SAFE Notice 2020

Number: 2-4473

Chullora Junction Upgrades

Stage 2 – West Junction and North Junction Upgrades with Both South Forks and North Fork Slew

Delete: Diagram NIB-T0643

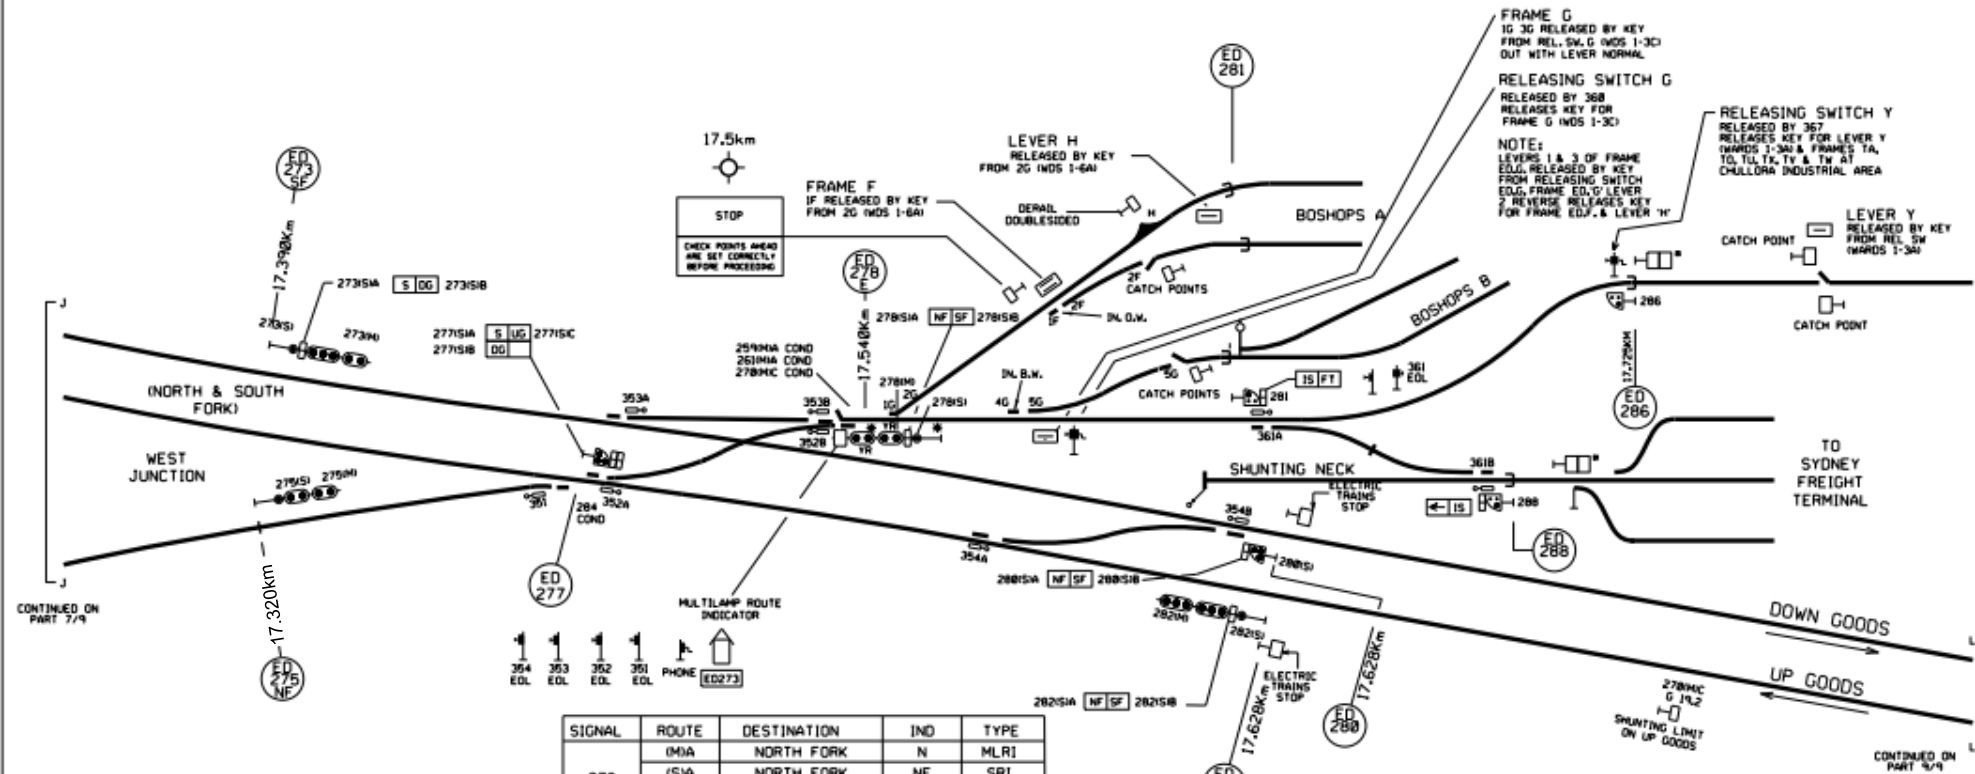
Amend below information in diagram NIB-T0643, Rev 1, dated 06/02/2019.

- Change the Km of ED275NF from “17.305km” to “17.320km”.
- Change the Km of ED280 from “17.600km” to “17.628km”. 354 crossover relocation to match the new Km.

- Change the KM of ED282 from “17.582km” to “17.628km”. 354 crossover relocation to match the new Km.
- Shunt limit sign between ED282 and ED284 to be facing Port Botany rather than facing Country.
- 354 crossover, signals ED280, signal ED282 and Shunt Limit sign to be relocated approx. 46m towards Country.
- Draw a catch point between 352B and 353A, shown as “CP 353B” and delete the “353B” word.
- Correct “353B” point logo to 2G ground frame. Correct the “G” ground frame to “5G” ground frame.
